RIVERSIDE
REGIONAL MEDICAL CENTER

Harold Prussia
License No.: 45-09001-01
Docket No.: 03003330
Control No.: 138016
December 9, 2005

This letter is in response to your request for additional information. Our response will answer each question with the same numbering system as in your letter.

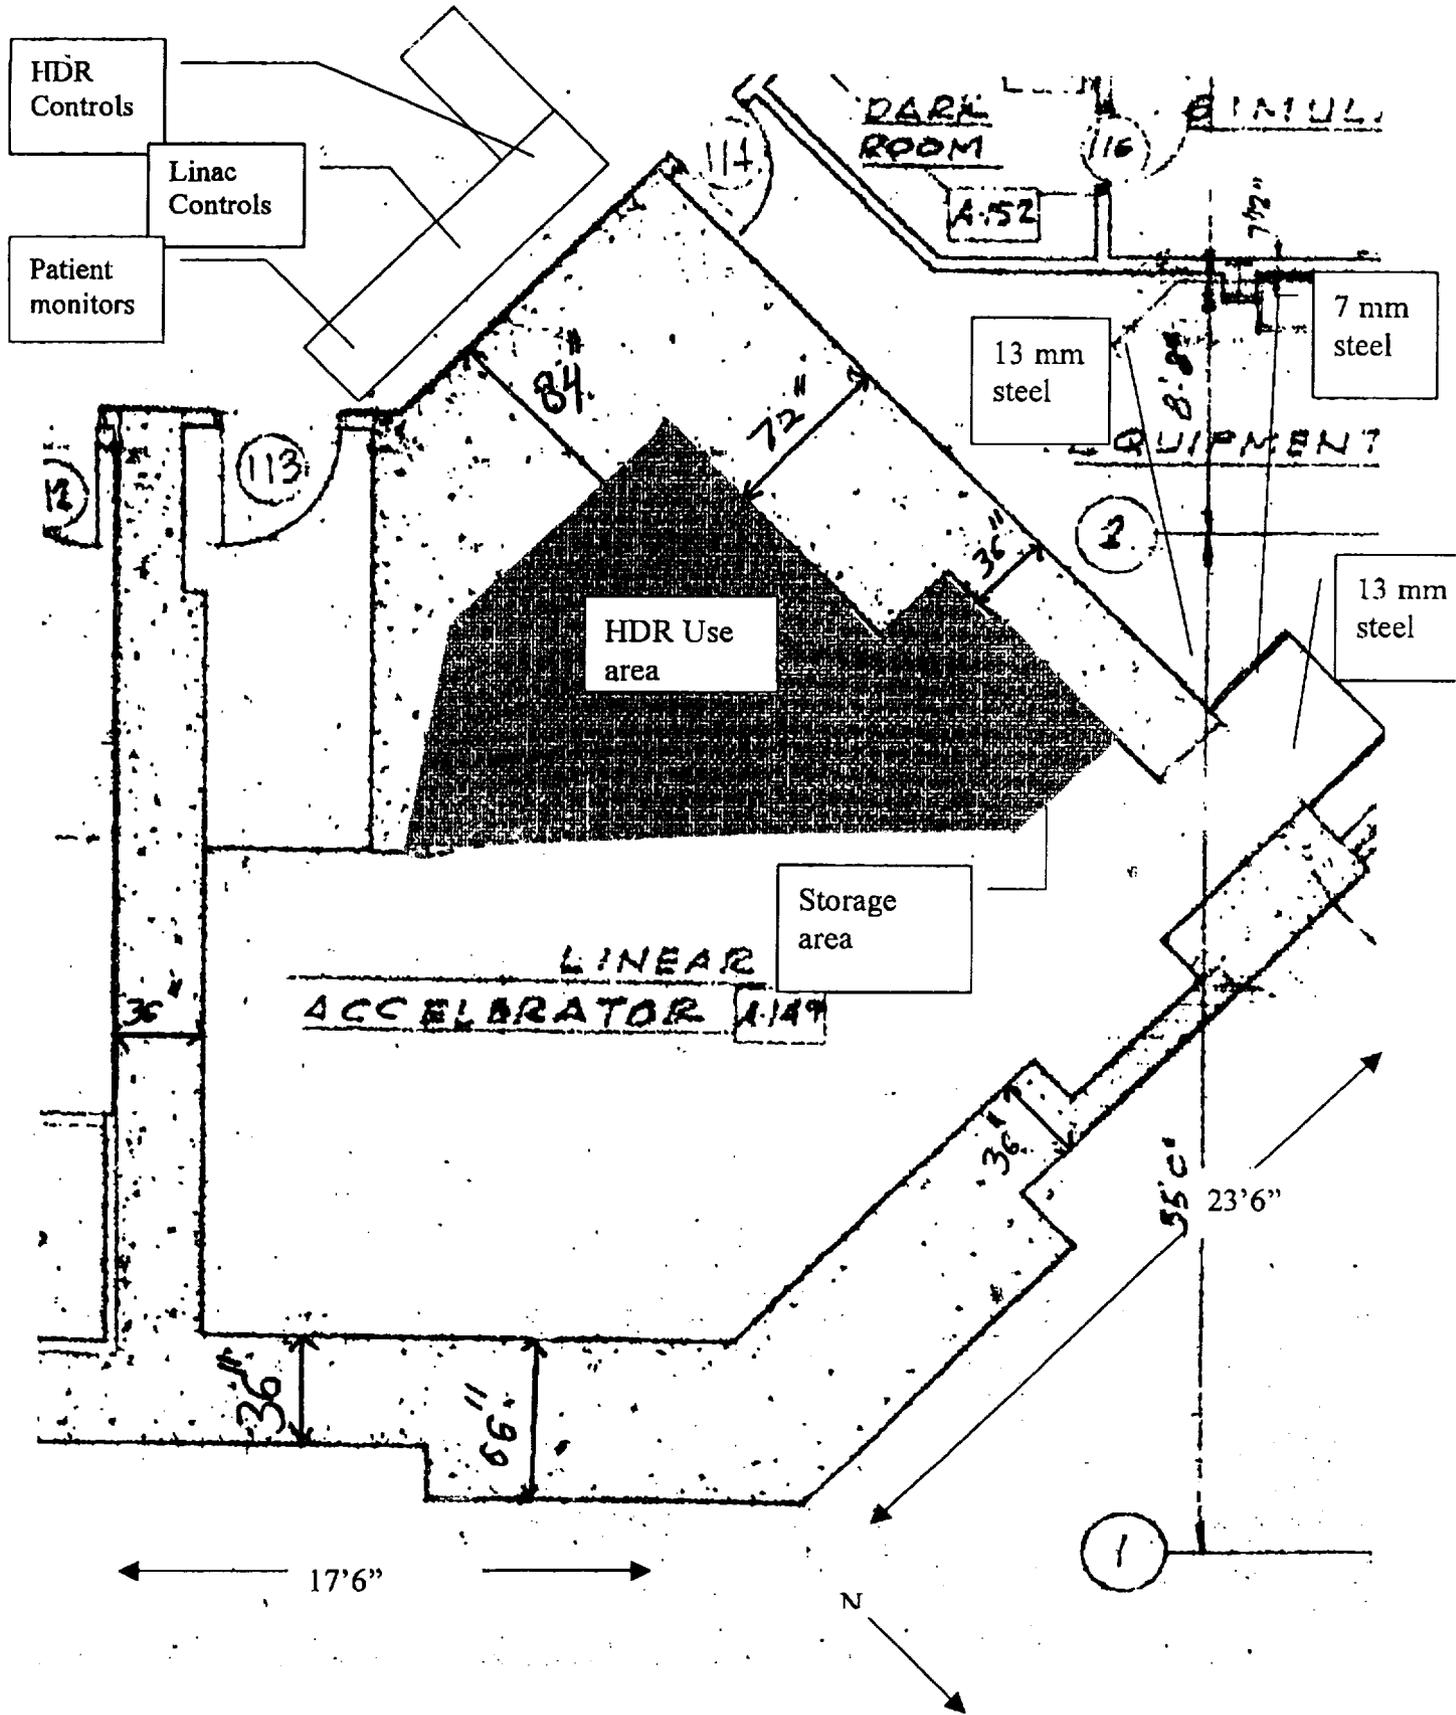
- 1)a). We have added the location of the HDR control panel to the drawing that was on page 6 of our original correspondence. The enhanced drawing is on page 3. of this response.

signs are posted on the outside of both doors before inserting the key in the HDR control. The appropriate door signage will comply with 10CFR20 and be determined by the results of an area survey with the source at point B in the drawing on page 3. The door signs will be attached by Velcro and removed after the control key has been removed from the HDR unit.

Response to Item 1b. See attached diagram

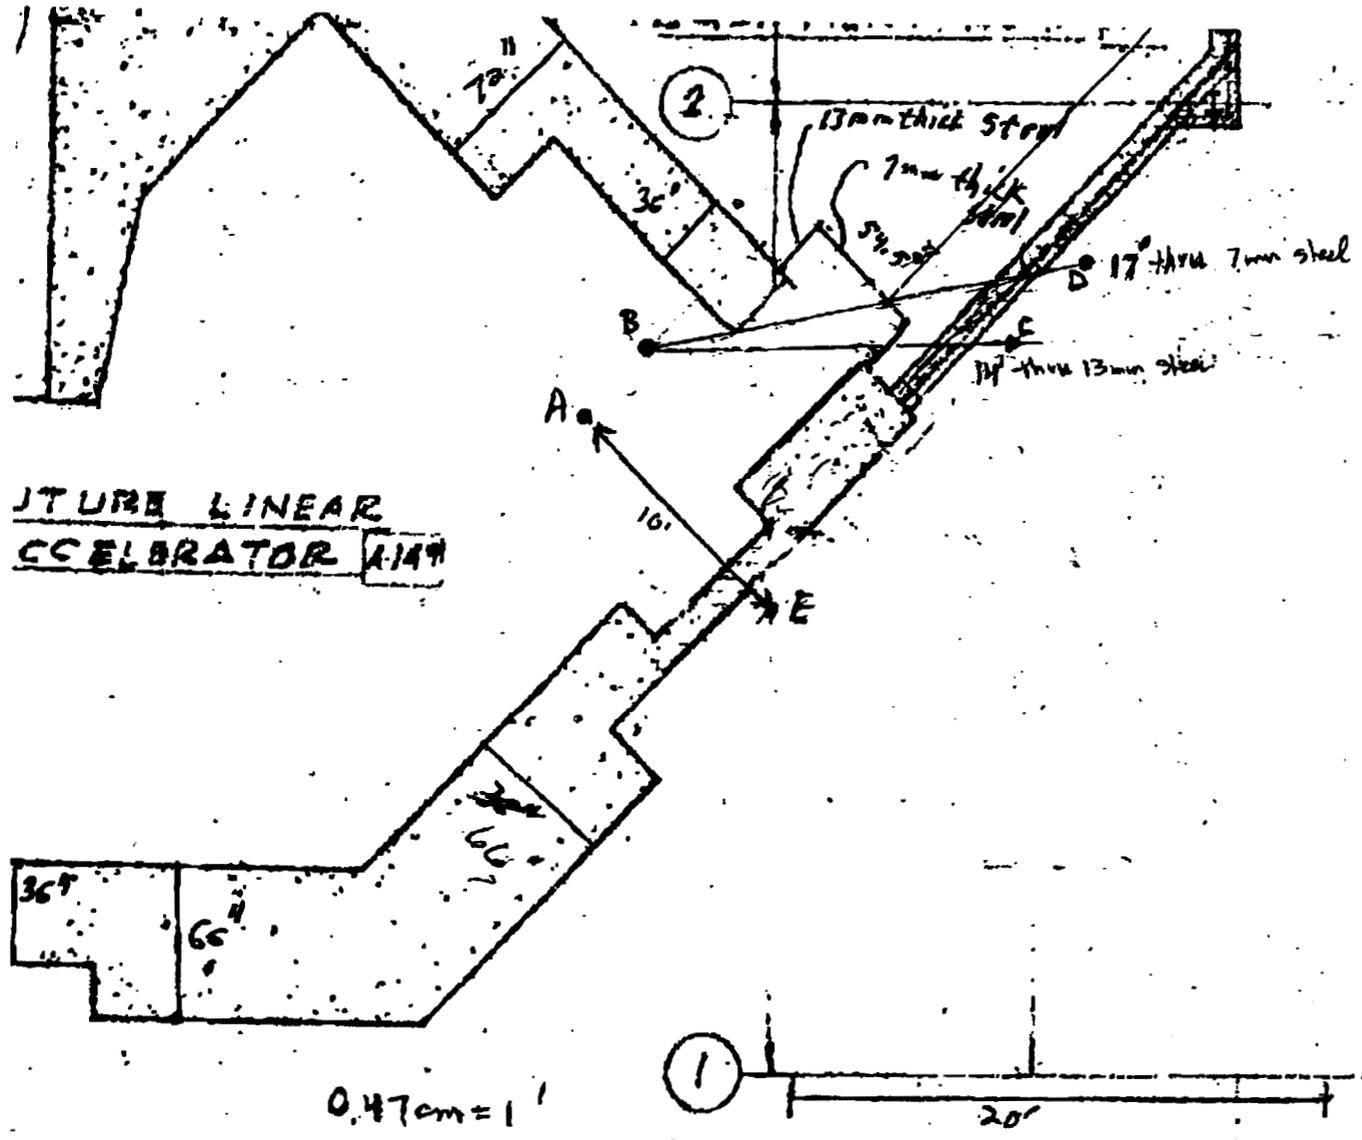
- 1)b). A more detailed explanation of the barrier calculations and drawing are on page 4 and 5 of this response. The added information and drawings along with the original calculations document the values and location of requested calculation points.

- 4). We confirm that the doses to individuals in areas beyond the equipment room will not exceed regulatory limits. Please see the attached explanation and drawing on page 4 and 5 of this response.

Point A is the source location assumed for the dose calculation beyond the knockout wall at point E. This source location is outside the designated source usage area, closer to the knockout wall than any point inside the designated usage area. Accordingly, it is used to demonstrate that dose to the public beyond the knockout wall is within regulatory limits even if the source is used closer to the wall that indicated by the designated usage area.

Point B is the source location assumed for the dose calculated at points C and D beyond the equipment room. Note that this source location is also slightly outside the designated use area, and permits radiation to pass through the steel cage, avoiding any of the thick vault concrete walls. Like the above, it is used to demonstrate that dose to the public outside the building beyond the equipment room are within regulatory limits even if the source is used outside designated usage area.

Point C is beyond the equipment room, through the 13 mm section of the steel cage, one foot beyond the outside wall.

Point D is beyond the equipment room, through the 7 mm section of the steel cage, one foot beyond the outside wall.

Point E is outside, one foot beyond the concrete knockout wall.

Beyond the equipment room is the outside parking area where points C and D are located. The dose at these points was calculated in the original report. The calculations were labeled "Yearly Dose Equivalent Outside the Building, Beyond the 13 mm Steel Cage" and "Yearly Dose Equivalent Outside the Building, Beyond the 7 mm Steel Cage." In all instances, the dose was within regulatory limits. (Note the typographical error in the original report. The distances to Points C and D were labeled as 14" and 17" respectively. The actual distances were 14' and 17'.)
